Coal Combustion Waste Impoundment

Round 7 - Dam Assessment Report

Walter Scott Junior Energy Center

MidAmerican Energy
Council Bluffs, Iowa

DOC 1.3 FINISH GRADES PLANS

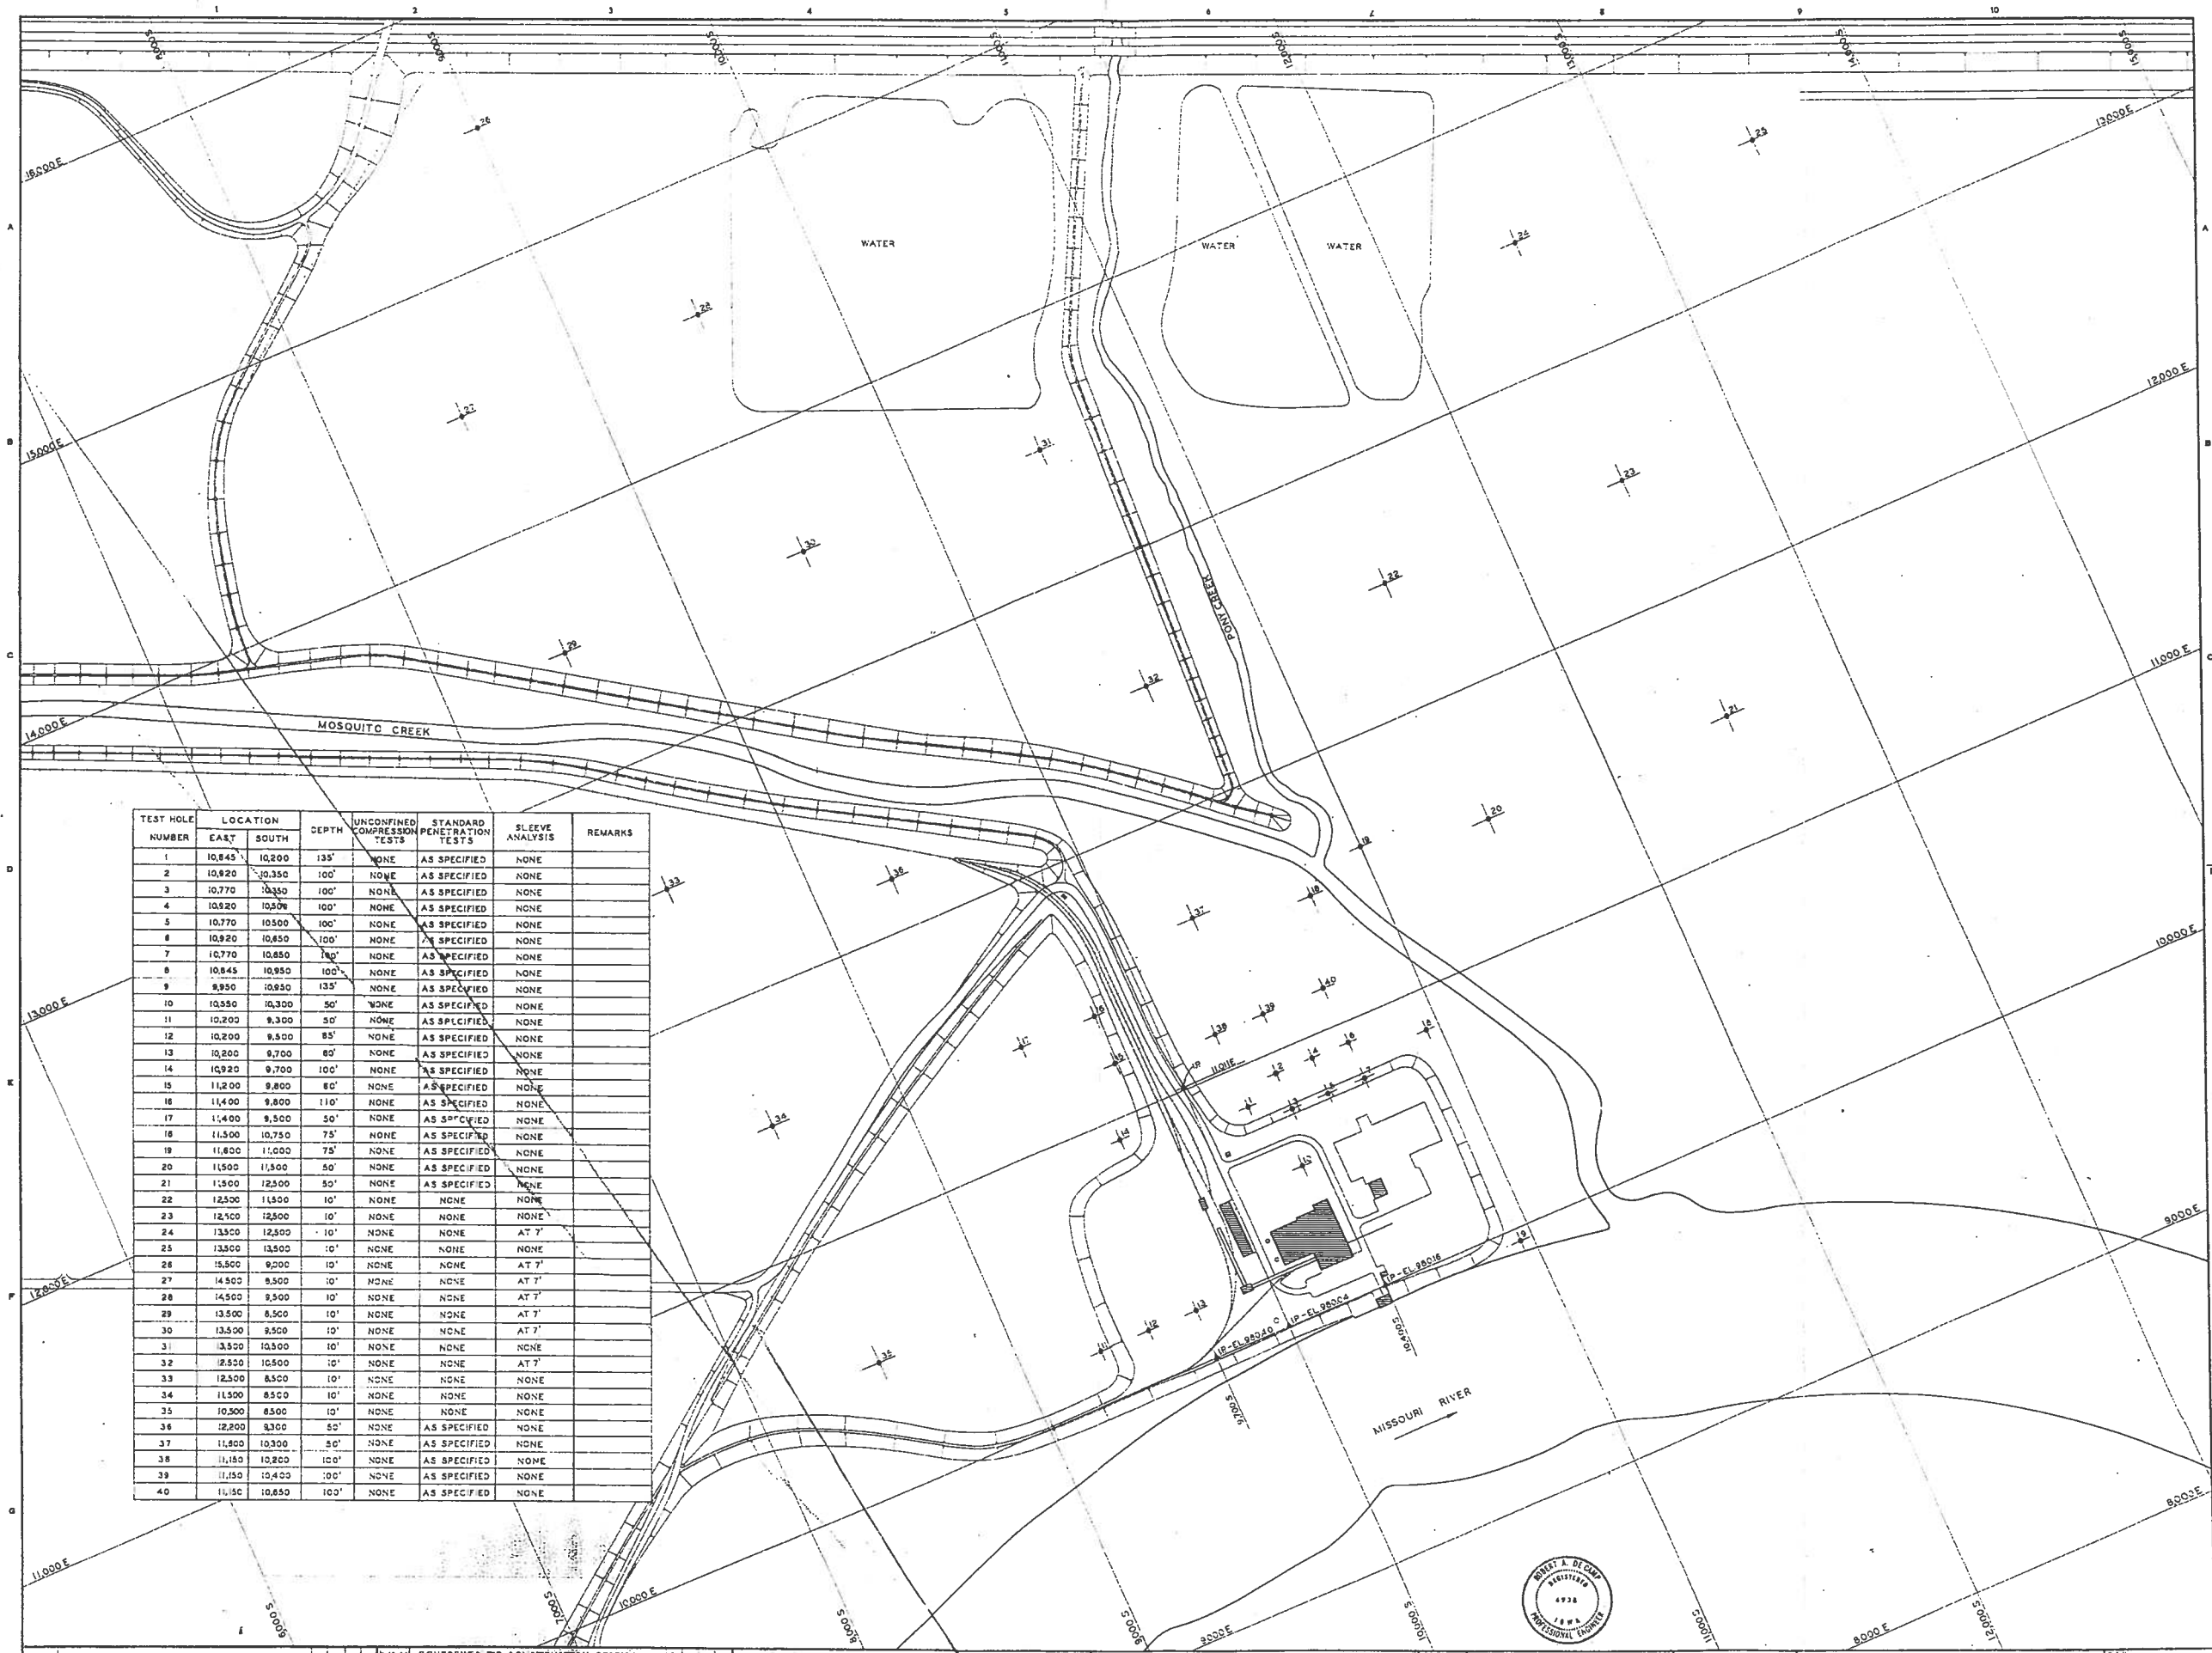
Supporting technical documents are generally adequate for the purposes of this review and assessment, although furnished drawings show original design features and do not reflect as-built features or all modifications that have been made since original construction (e.g., the SIRE railroad embankment built across the western part of the ash basins does not show on any of the furnished drawings).

horizontal (H) to 1 vertical (V) side slopes. The final design grades of the levees and dikes of the North Ash Pond are shown on the Finish Grades plans in Appendix C - Doc 1.3. However, the crest of the south side levee is actually about 3 feet higher than shown on the Finish Grade plans. MidAmerican indicated that the USACE raised the Mosquito Creek and Pony Creek levees in the early 1980s, and the change in height resulted in a slope of the crest from elevation 982 feet to 983 feet. However, a recent survey of crest elevations around the perimeter of the pond suggests that the Mosquito Creek levee was not raised (see Appendix D - Item 2).

Update project documents to include or note current features of the ash basins and modify or supplement the documents as needed when changes are made in the future. For example, the recently completed crest elevation profiles around both ash ponds surveyed by HGM Associates, Inc. (Appendix D - Item 2) serves to provide documentation of current crest elevations, which should be referenced on official project plans.
